ZZA-Terracon Project No.: 81085165

Subject: Revised Preliminary Geotechnical Engineering Evaluation  
Proposed Jennifer Dunn Memorial Park  
King County, Washington

Subject: Preliminary Geotechnical Engineering Evaluation  
Proposed Jennifer Dunn Memorial Park  
King County, Washington

**SITE PLAN**  
 Jennifer Dunn Memorial Park  
 King County, Washington  
 Prepared for: RTW Associates

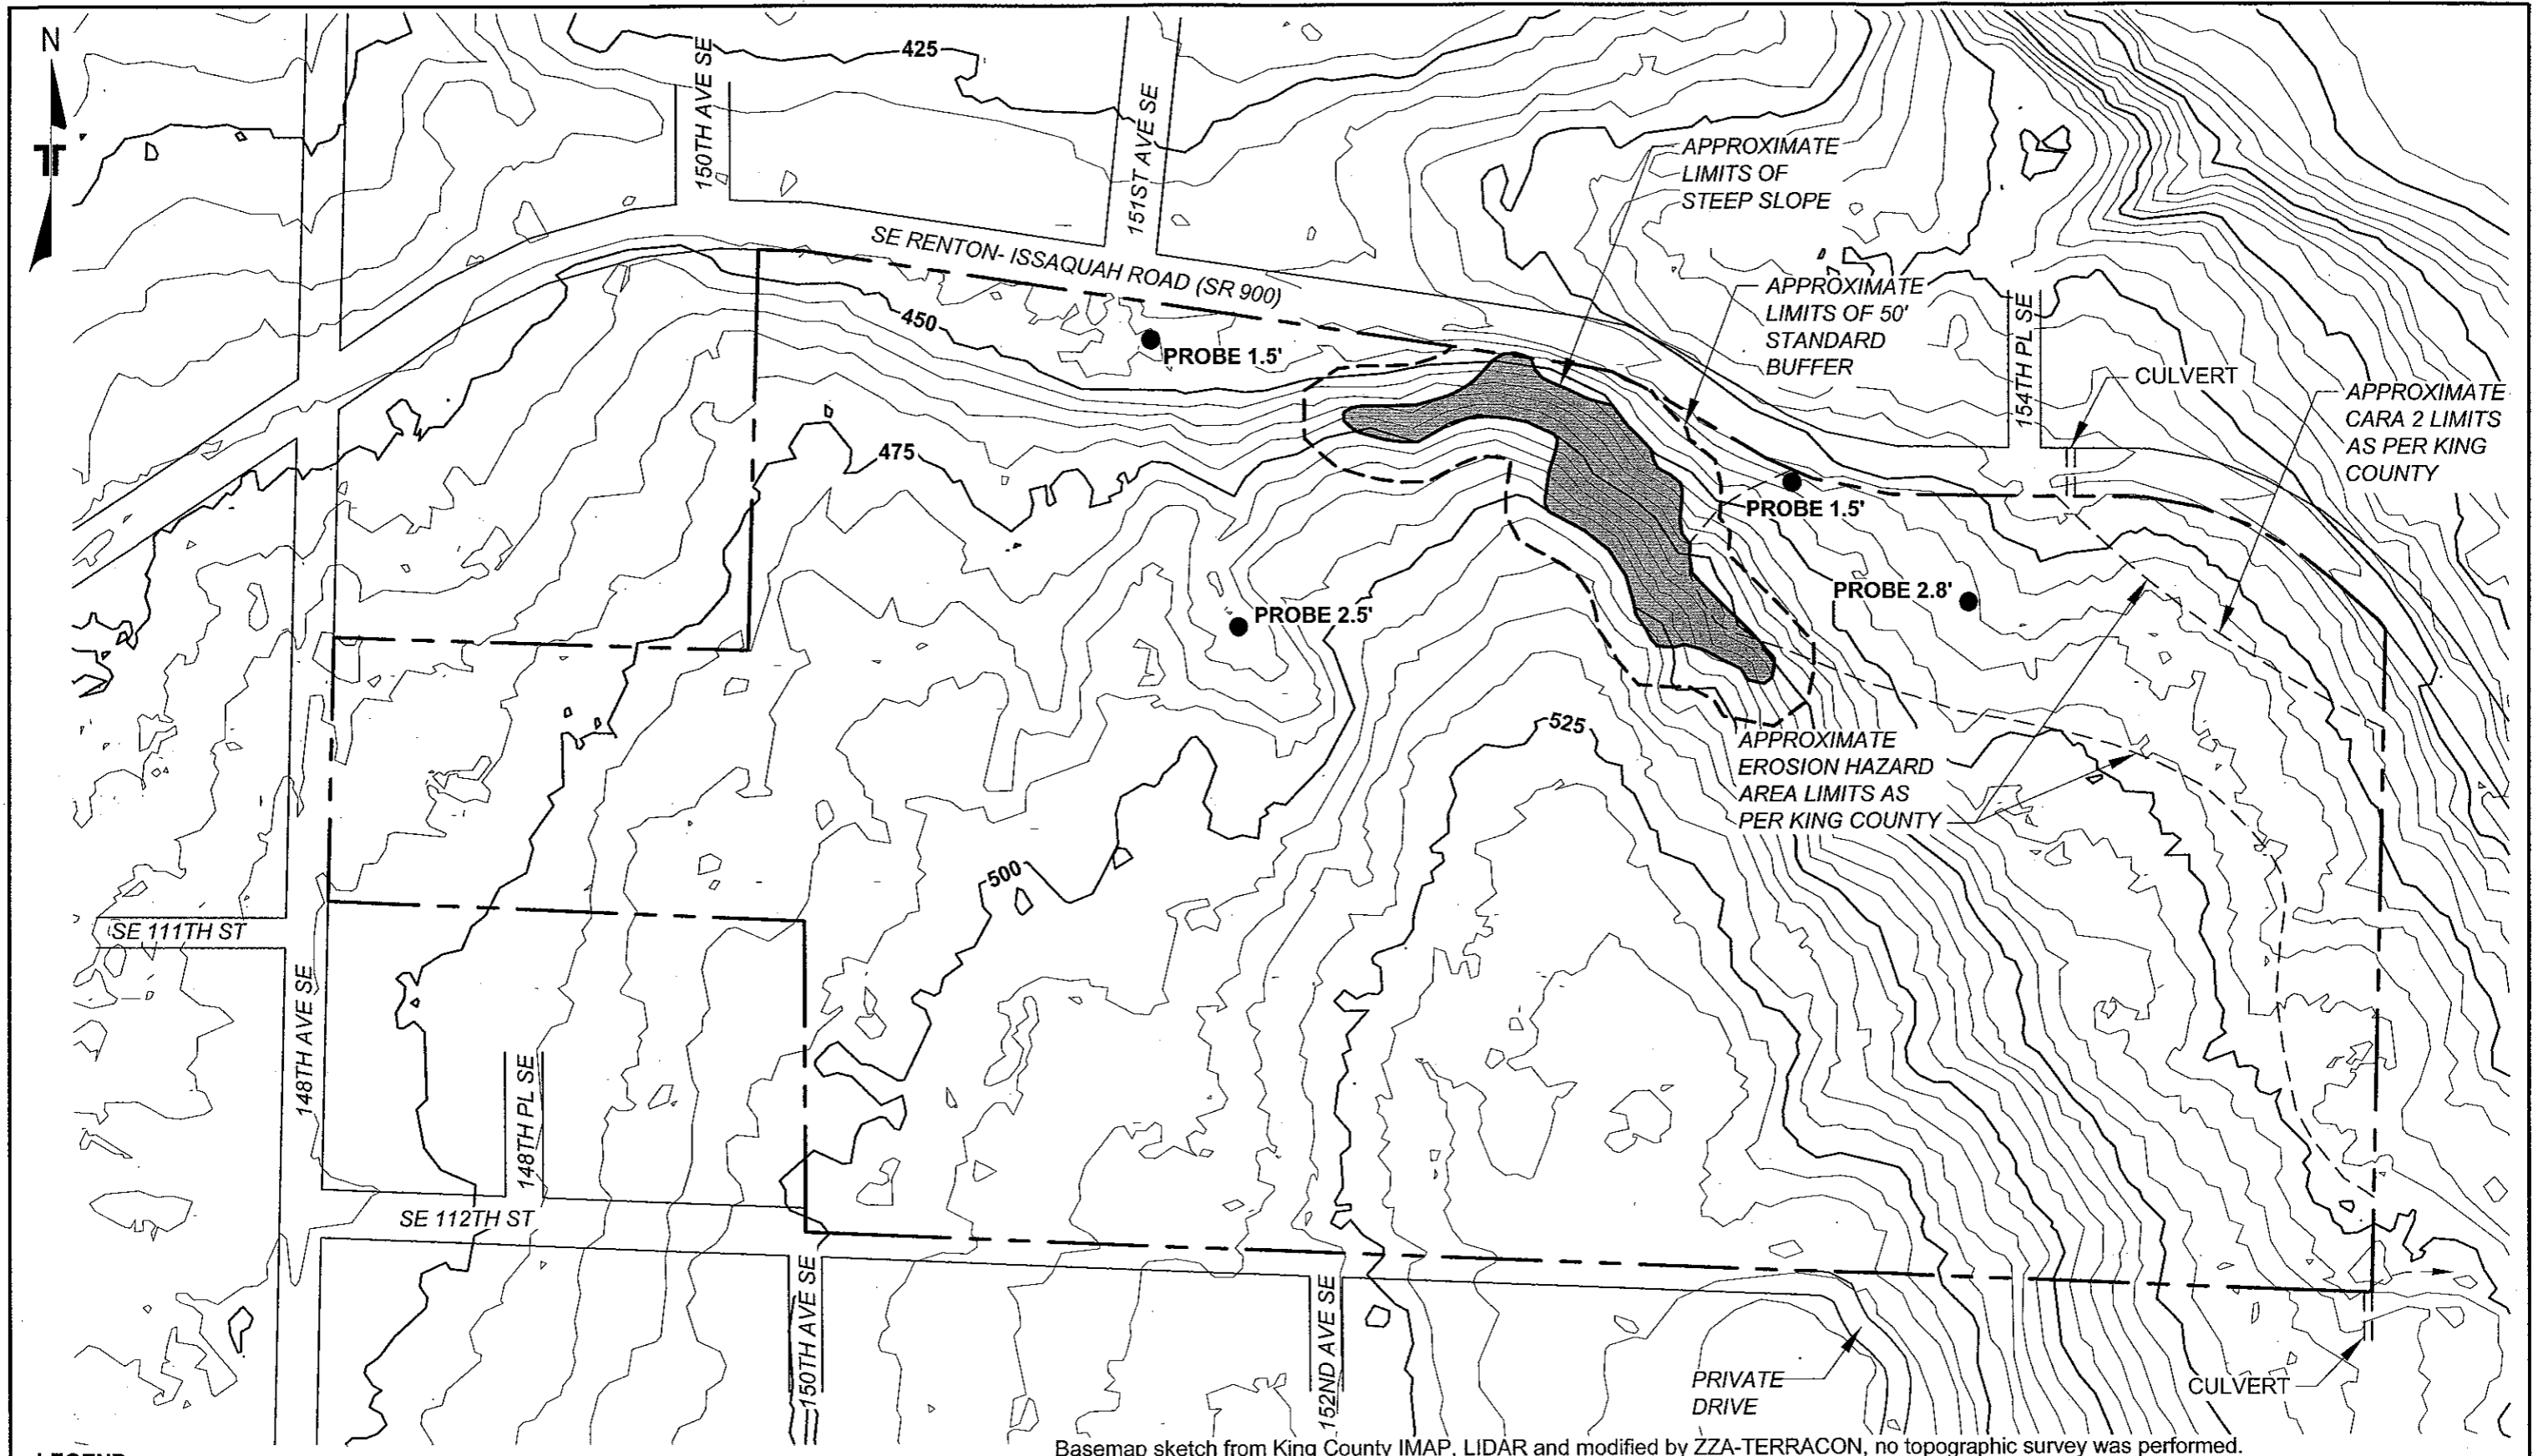
The enclosed reports include the revised Figure 1, Site and Exploration Plan, that shows the approximate limits of the regulated steep slope area and the standard 50 foot buffer described in the King County Code. The report text has not changes. We will forward a copy of the report as a pdf and also a copy of the base plan as a CAD file, as per your request.
